UNITED STATES PATENT AND TRADEMARK OFFICE

APPLICATION NO.	FILING DATE	FIRST NAMED INVENTOR	ATTORNEY DOCKET NO.	CONFIRMATION NO.
10/563,532	12/20/2005	Heino Messerschmidt	20037.1001USWO	8331
52835 7590 01/08/2008 HAMRE, SCHUMANN, MUELLER & LARSON, P.C. P.O. BOX 2902 MINNEAPOLIS, MN 55402-0902			EXAMINER SCHILLER, ALINA	
			ART UNIT 3671	PAPER NUMBER
			MAIL DATE 01/08/2008	DELIVERY MODE PAPER

Office Action Summary

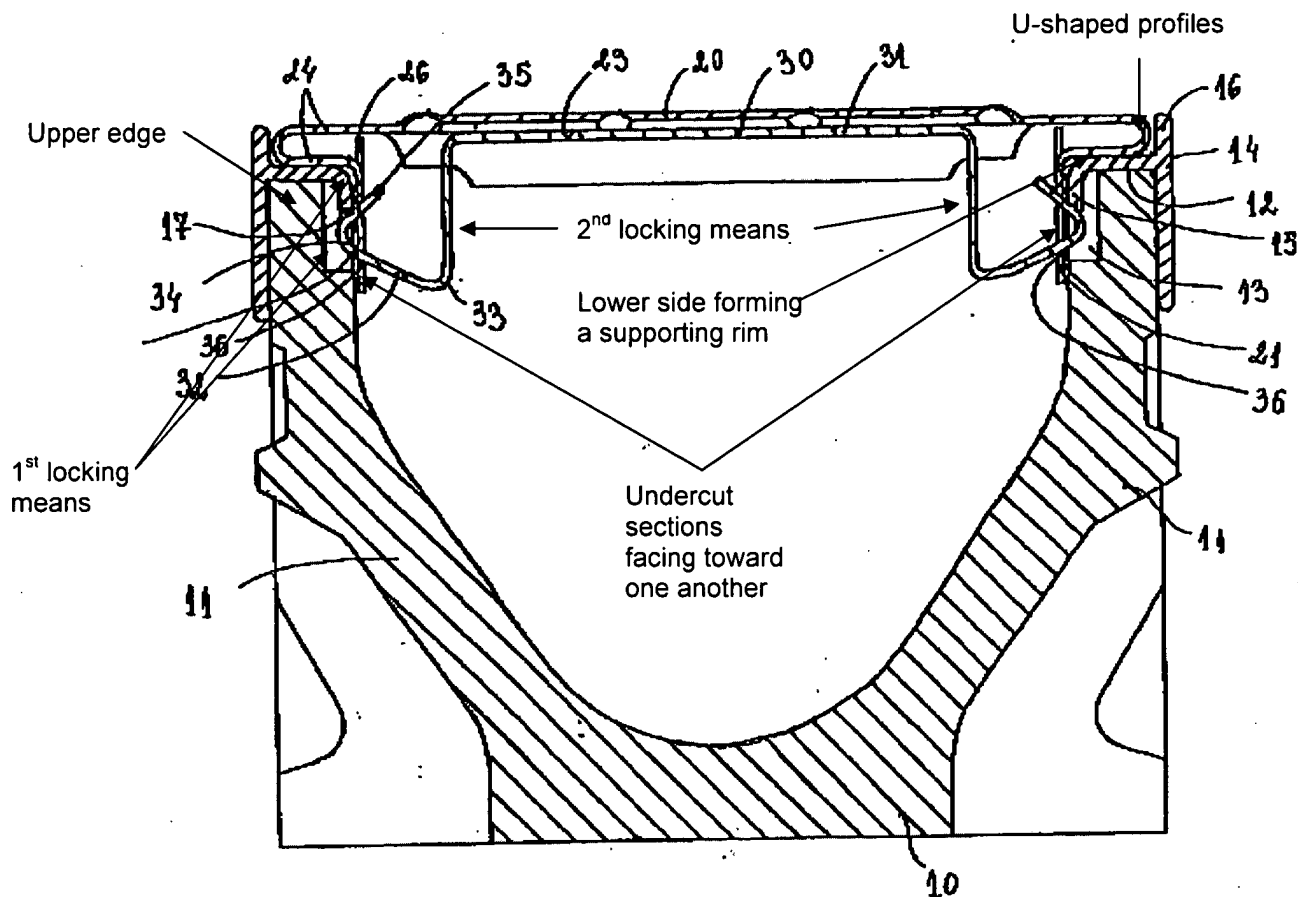
Regarding claim 1, Rathmann discloses a surface water drainage system (as seen in Fig. 1), comprising

a structure (10) adapted for installation in the ground such that it defines an upper edge and comprising a first locking means (as seen in the modified picture below taken from Fig. 1);

a cover (20) adapted for location on the upper edge of the structure and fabricated from sheet metal ([0020], lines 1-2) having edges forming U-shaped profiles with undercut sections that face toward one another and with a lower side forming a supporting rim (as seen in the modified picture below); and

fixation devices (30; claim 1, line 5) attached to said edges of the cover and comprising second locking means in the form of elastic hook elements ([0011]; [0014], line 6; claim 6, line 7) that are mounted within said undercut sections and that are adapted for snapping engagement ([0014]) with said first locking means on the structure in order to retain the cover on the structure (as seen in the modified picture below; [0027], lines 5-6).

a structure (10) adapted for installation in the ground such that it defines an upper edge and comprising a first locking means (as seen in the modified picture above);

fixation devices (30; claim 1, line 5) attached to said edges of the cover and comprising second locking means in the form of elastic hook elements ([0011]; [0014], line 6; claim 6, line 7) that are inserted into said recesses (as seen in the modified picture above) and are adapted for snapping engagement ([0014]) with said first locking means on the structure in order to retain the cover on the structure (as seen in the modified picture above; [0027], lines 5-6).
